Subject ▶ Change on Spiral Bevel Gears

For Models ▶ DA3000R,DA3000V,DA3000 (Angle Drills)

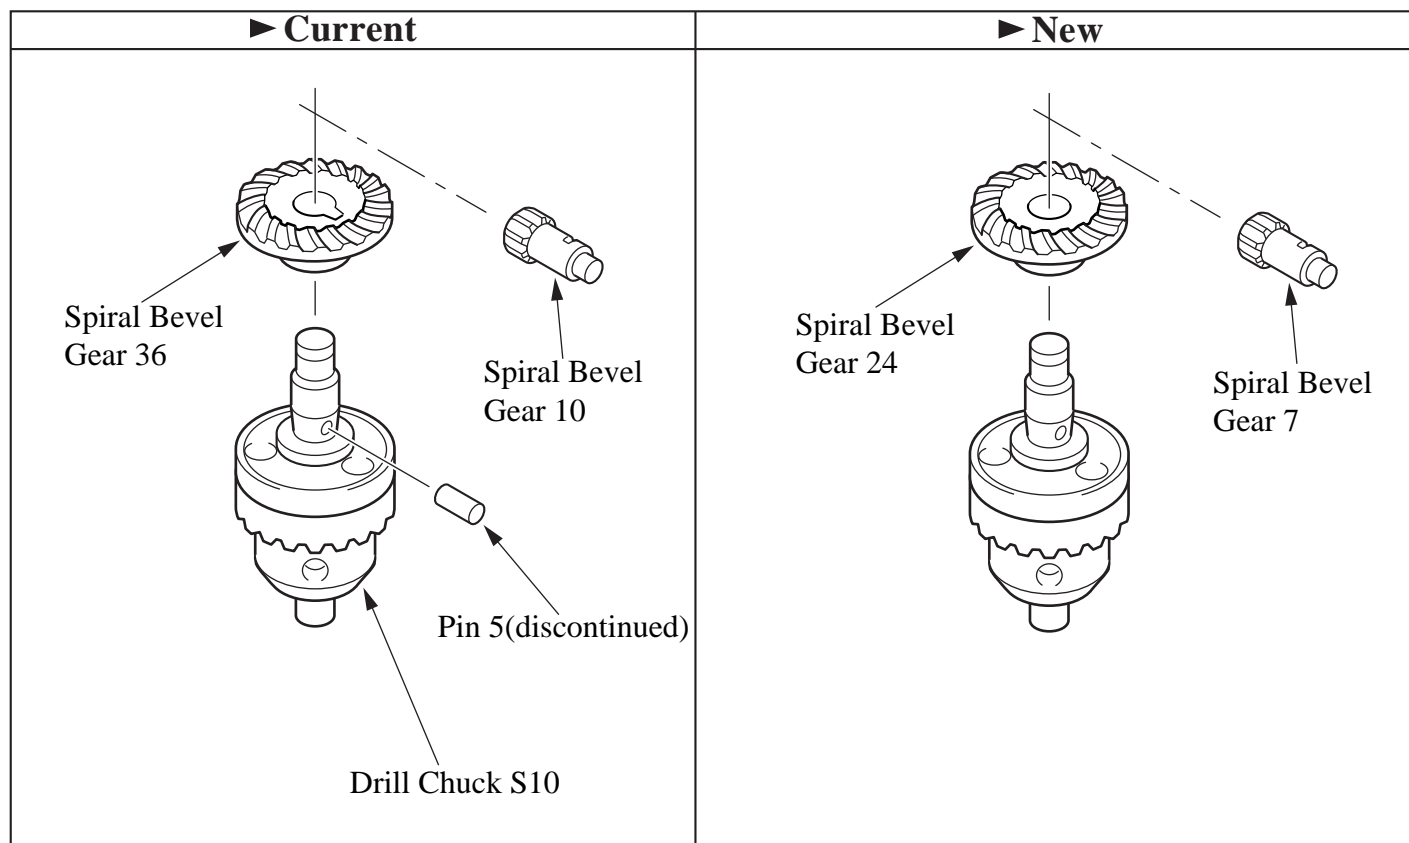
Description ▶ As illustrated below, Spiral Bevel Gears have been changed, for more endurance.
Pin 5 has been discontinued.

; Please be sure to change Spiral Bevel Gears as a set.
; Spiral Bevel Gear 24 is to be pressed in.

Item No.	Current part		Q'ty	I/C	New part		Q'ty	Note
4	Spiral Bevel Gear 10 221342-1		1	NO	Spiral Bevel Gear 7 226751-9		1	Interchangeable sa a set
23	Spiral Bevel Gear 36 221343-9		1	No	Spiral Bevel Gear 24 226752-7		1	
24	Pin 5 256023-8		1
